# ORIGINATION FORM •

## Proposed Revisions to a Standard Plans Index

Index Number: 641-020 Sheet Number (s): All Index Title: Concrete CCTV Pole

INDEX	SHEET
641-020	1 of 5

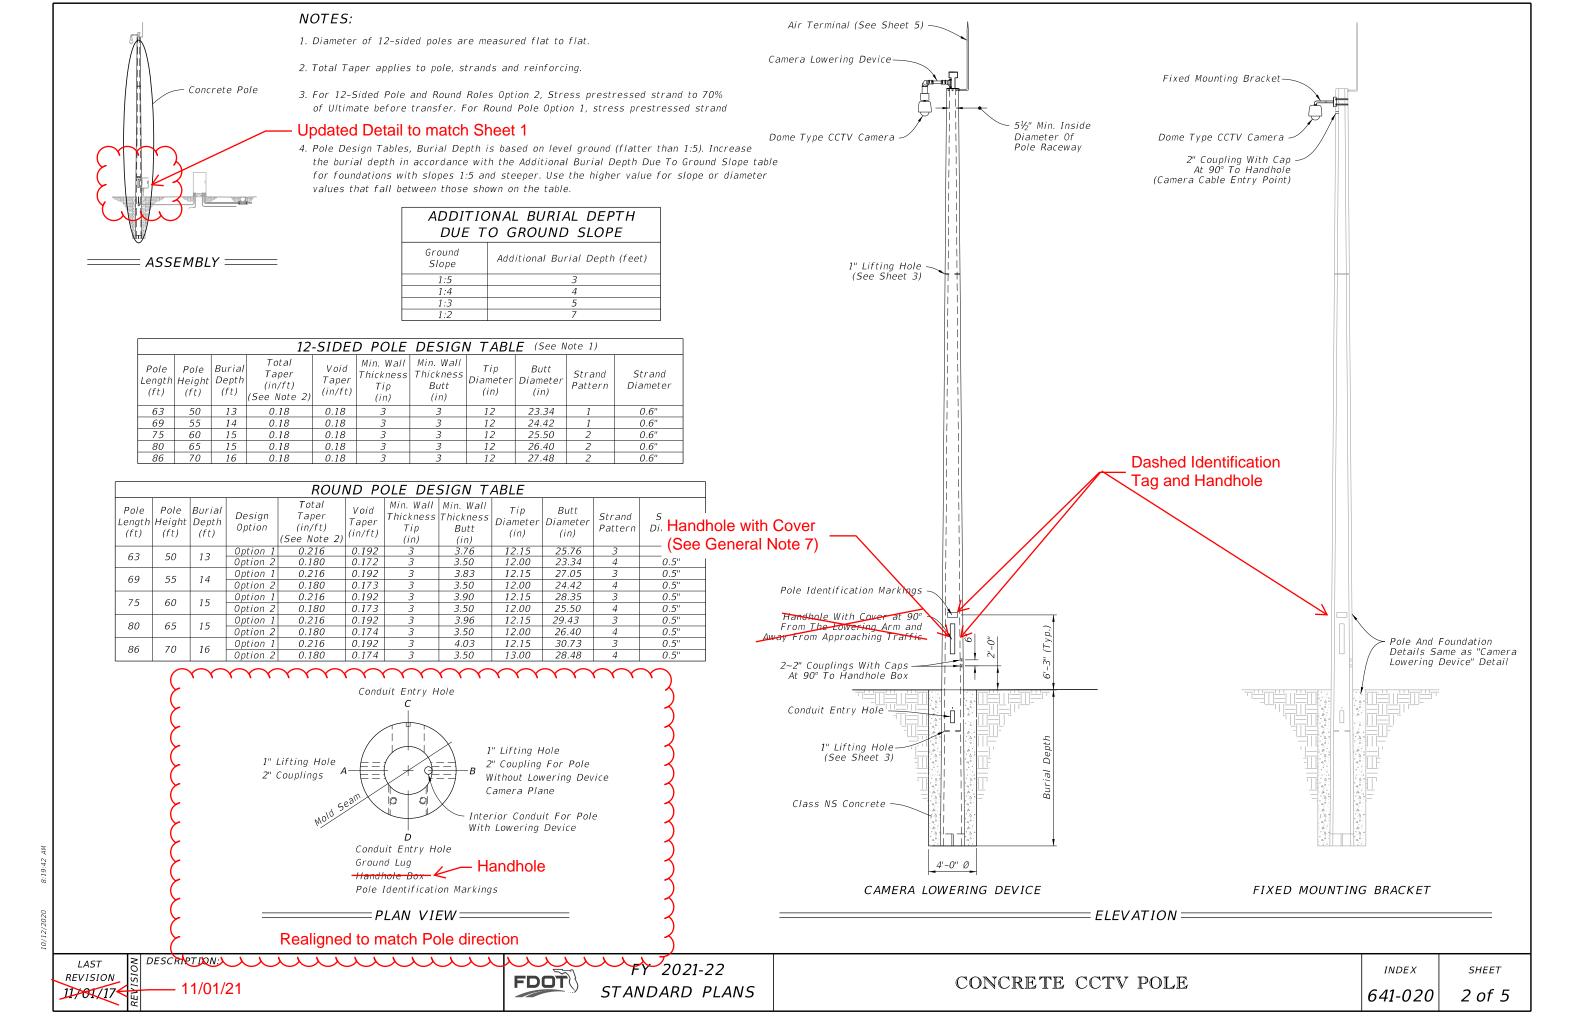
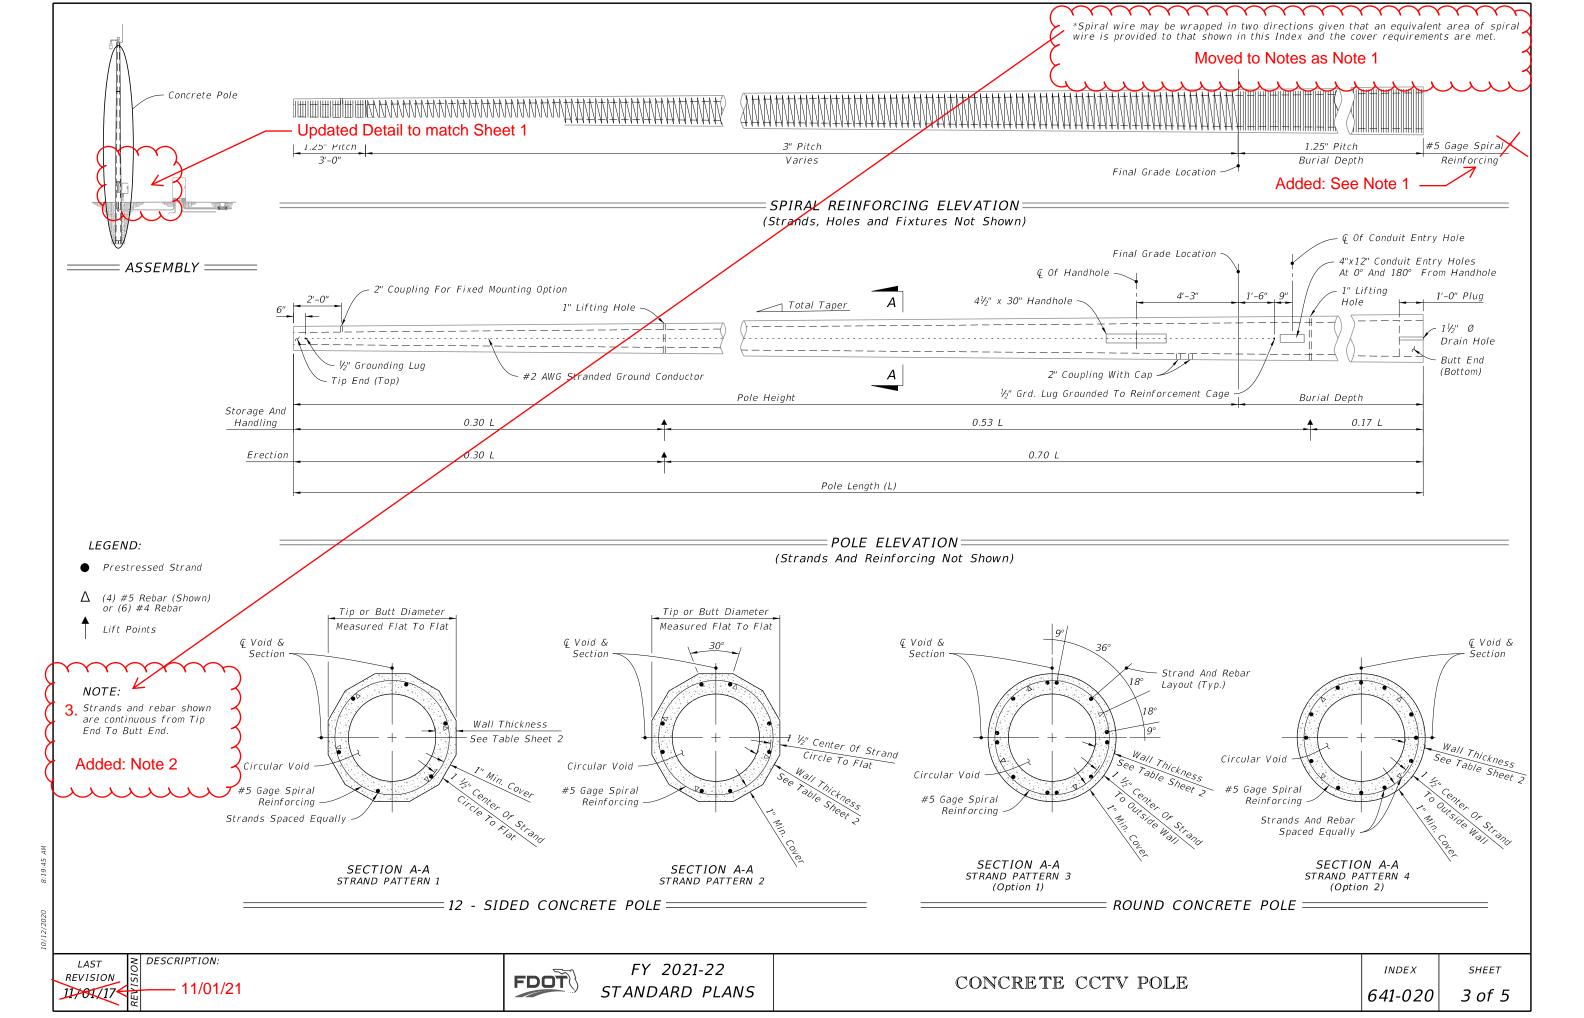
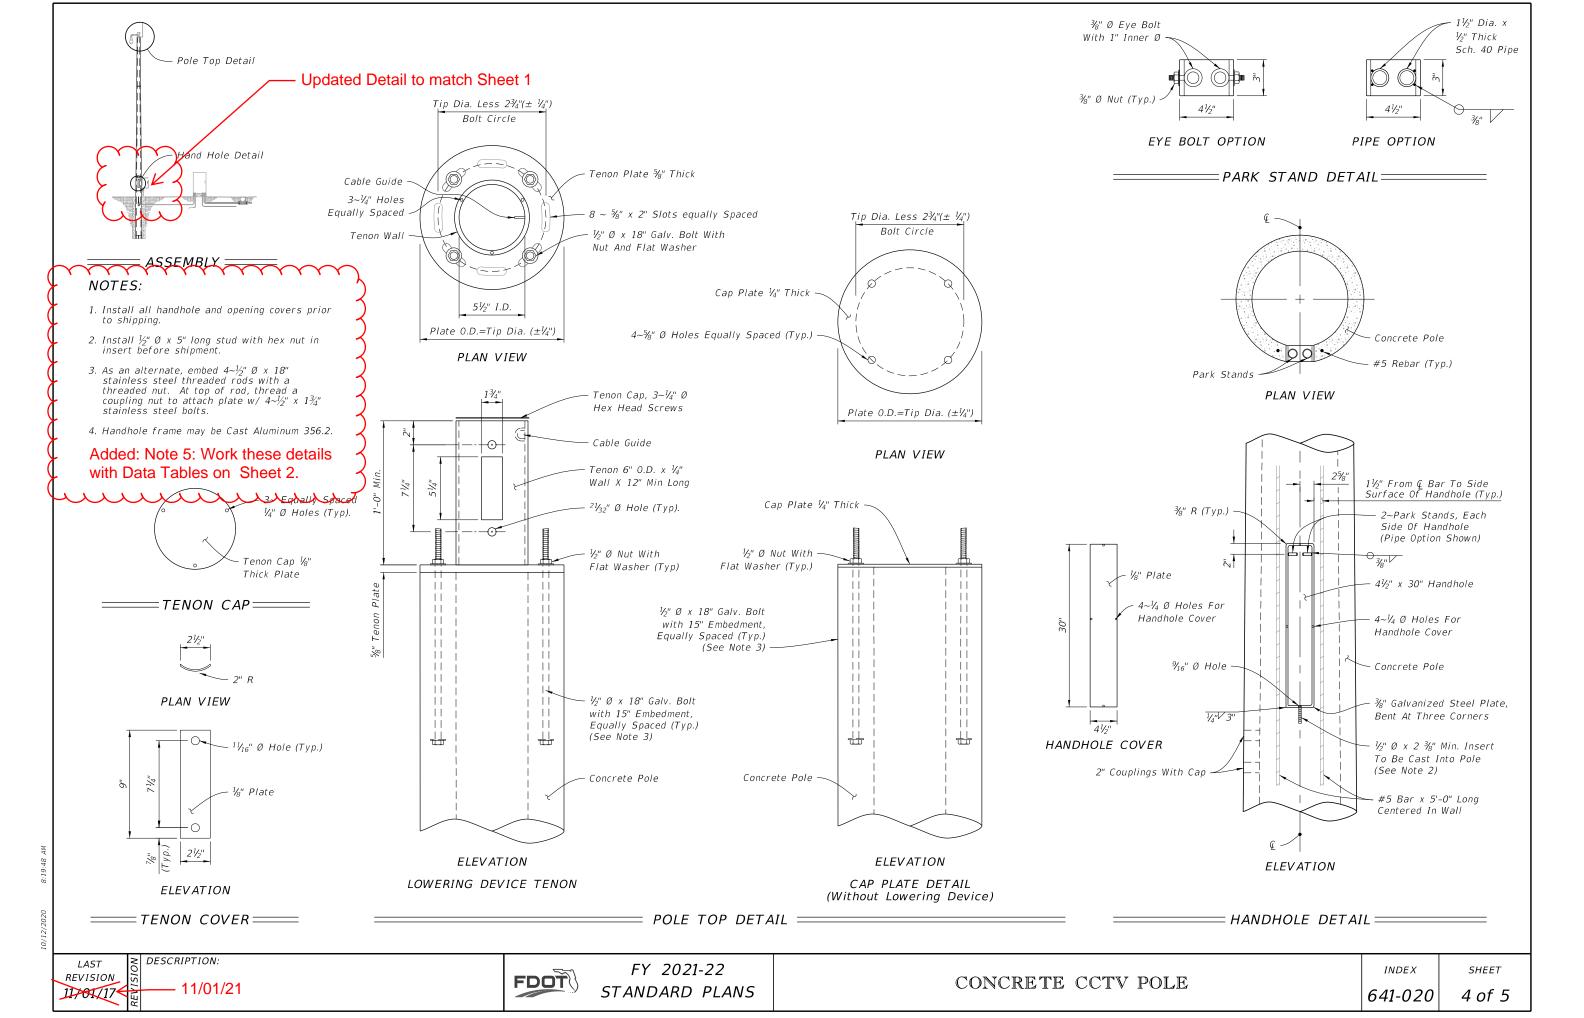
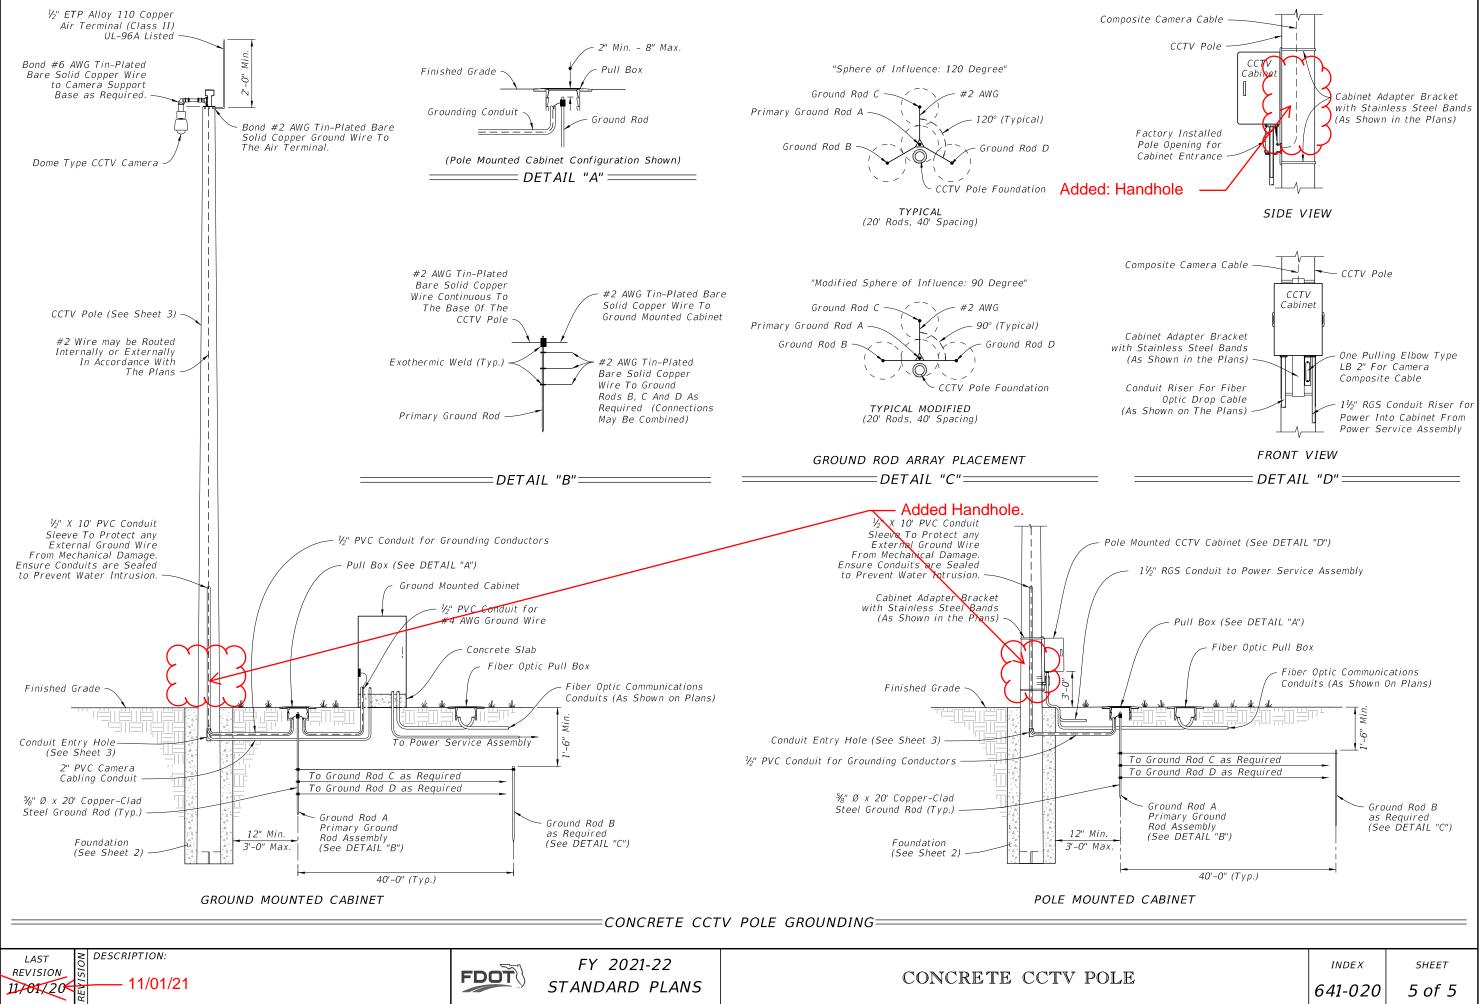
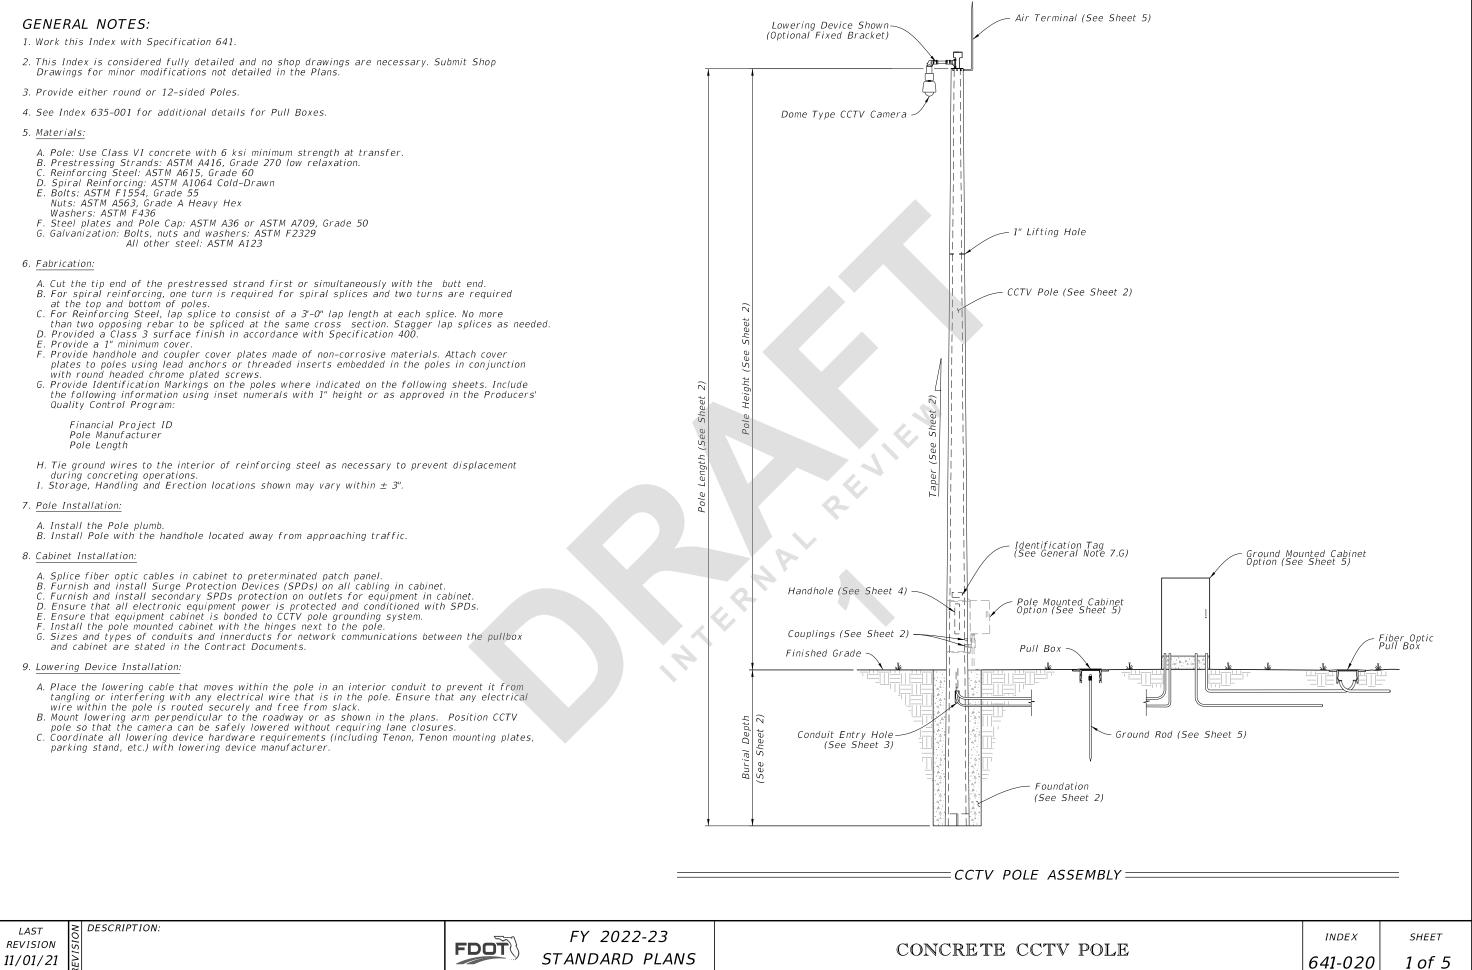
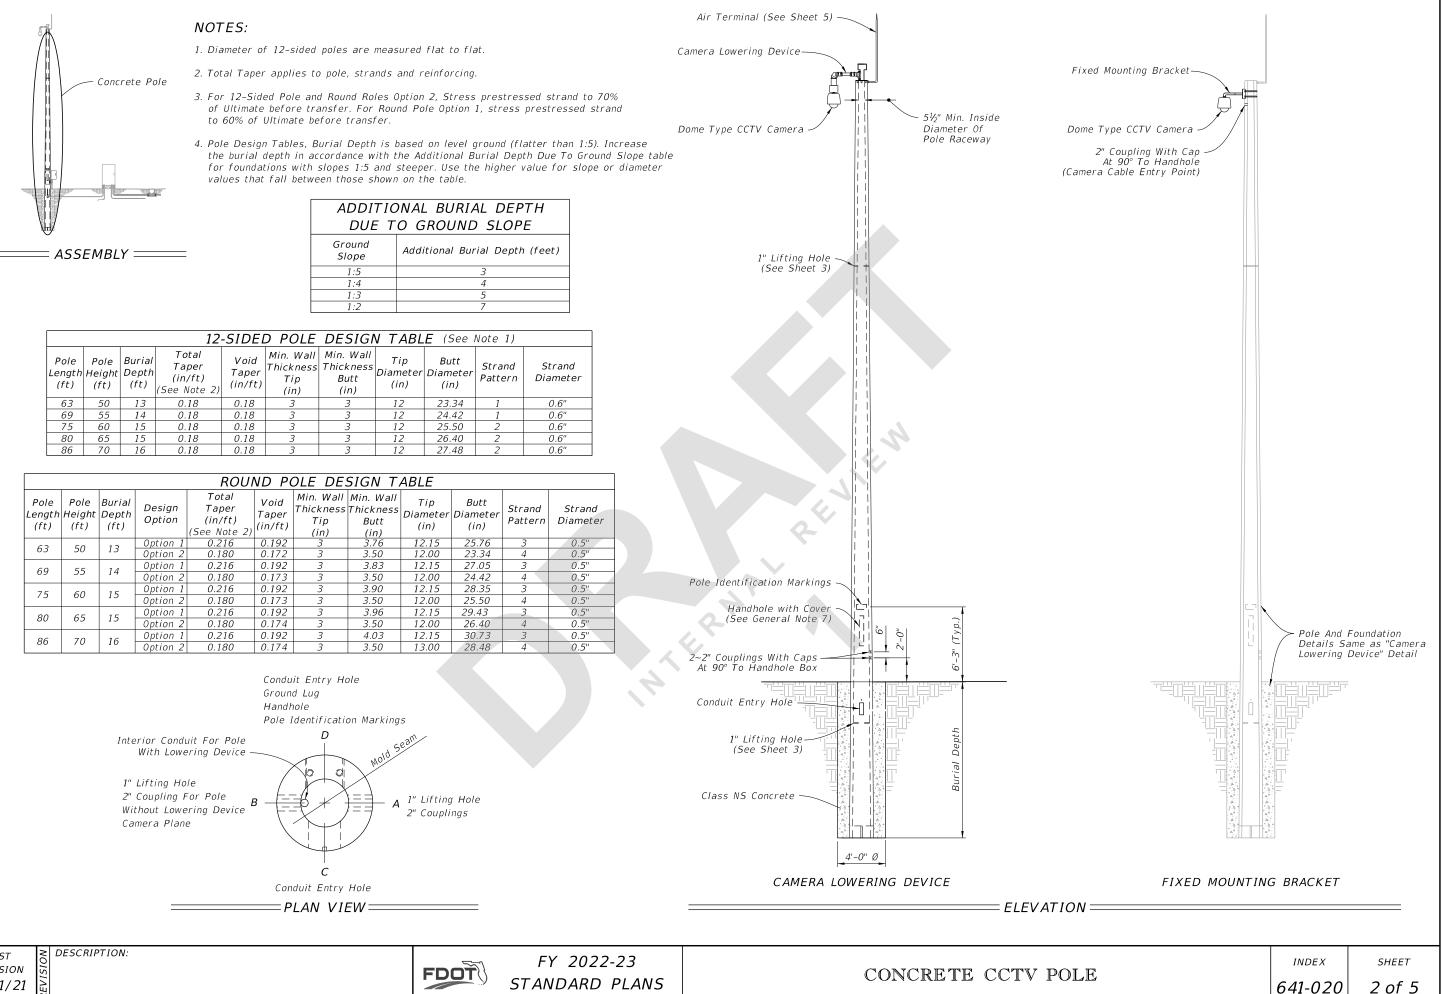
Sheet 1: Move Note 3 to new Note 7; Added Note 7; Renumbered General Notes; Dashed the Identification Tag and the handhole in the CCTV POLE ASSEMBLY detail.

Sheet 2: Updated the Assembly detail to match Sheet 1; Realigned the PLAN VIEW detail to match the Pole direction;

Dashed the Identification Tag and the Handhole in the ELEVATION detail.

Sheet 3: Updated the Assembly detail to match Sheet 1; Moved the Spiral wire note in the SPIRAL REINFORCING ELEVATION detail to the Notes and added See Note 1 to the Spiral Reinforcing call out; Dashed the Conduit Entry Holes in the POLE ELEVATION detail to be consent with the Pole's view.

Sheet 4: Updated the Assembly detail to match Sheet 1; Added Note 5.

Sheet 5: Added Handhole to the CONCRETE CCTV POLE GROUNDING detail and to DETAIL "D"-SIDE VIEW detail.

The location of the couplings shown on the CCTV Pole Assembly on sheets 1 and 2 do not correlate with the location of the couplings shown on the Pole Elevation and Handhole Detail shown on sheets 3 and 4. The handhole should be located downstream of the traffic so all details and notes will be updated for the proper representation.
